Land at Pixiefields, Cradley, Herefordshire

Resubmission Statement

May 2019

Extract from Landscape Proposals

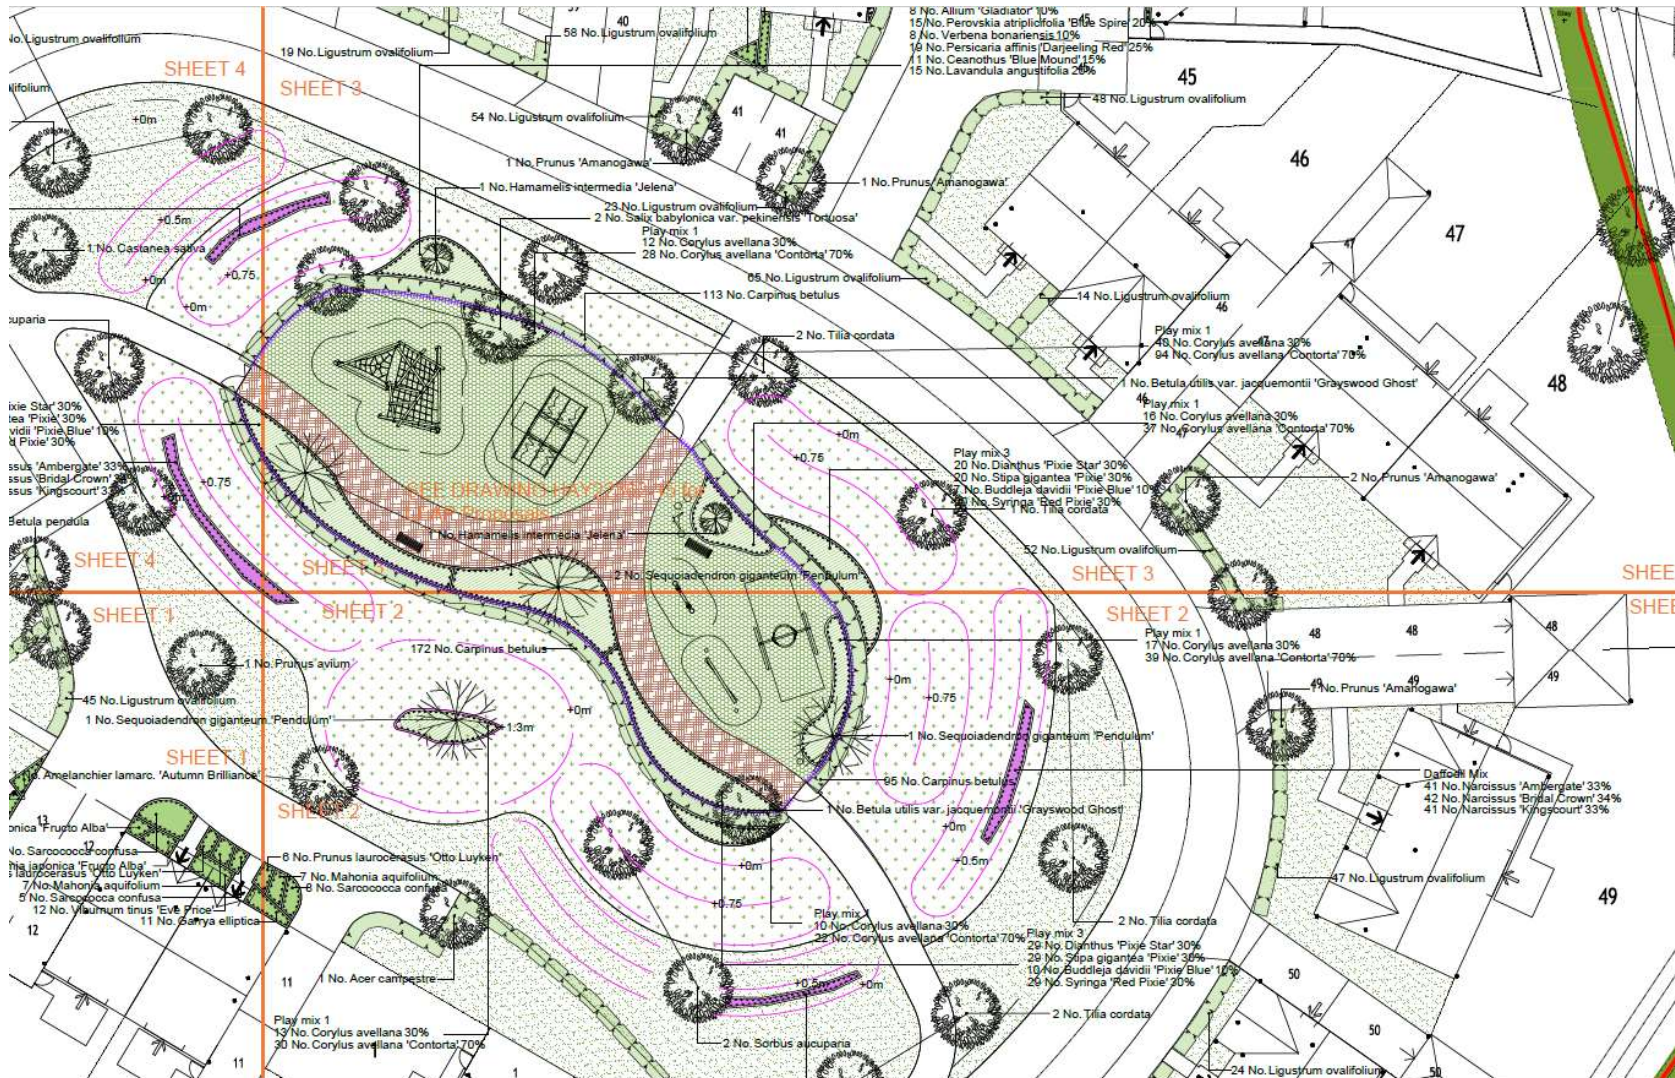
In response to the comments made by the Landscape and Open Space Officers several amendments and improvements have been made.

Whilst Plots 1 and 2 have not been re-oriented to open up greater views across the centrally located area of POS upon immediate arrival into the site, due to the knock-on negative impact this would potentially have upon separation distances and garden sizes, further landscaping has been provided to the front of these plots, which were already set-back significantly from the road.

- The re-positioning of the footpath link through the POS, which runs alongside the principal internal road for a greater length than previously proposed, provides greater crossing opportunities to link both the central and south-eastern areas of open space sufficiently;

- An area of Natural Play, meeting the Open Space Officer's requirements for a Locally Equipped Area of Play, has been provided within the central area of POS, with a new pathway running through the centre of the LEAP, encouraging interaction and better responding to likely pedestrian desire lines;

- The proposed tree planting within the main POS area has been pushed out to the periphery as requested, to enable greater informal recreational use of the open space surrounding the formal area of play;

- Greater landscaping has been included within parking-court areas, to soften their appearance and improve their aesthetic;
- Detailed landscape proposals have been provided for the attenuation basin area of the site, which our drainage engineers have confirmed will be a predominantly dry feature comprising less than 1:3 gradient banks, enabling its dual use as an area of informal recreation without the need for an unnecessary boundary treatment; and

- Far in excess of 0.165ha of on-site green infrastructure has been provided of the type and breakdown requested, including in excess of a 400m² LEAP.
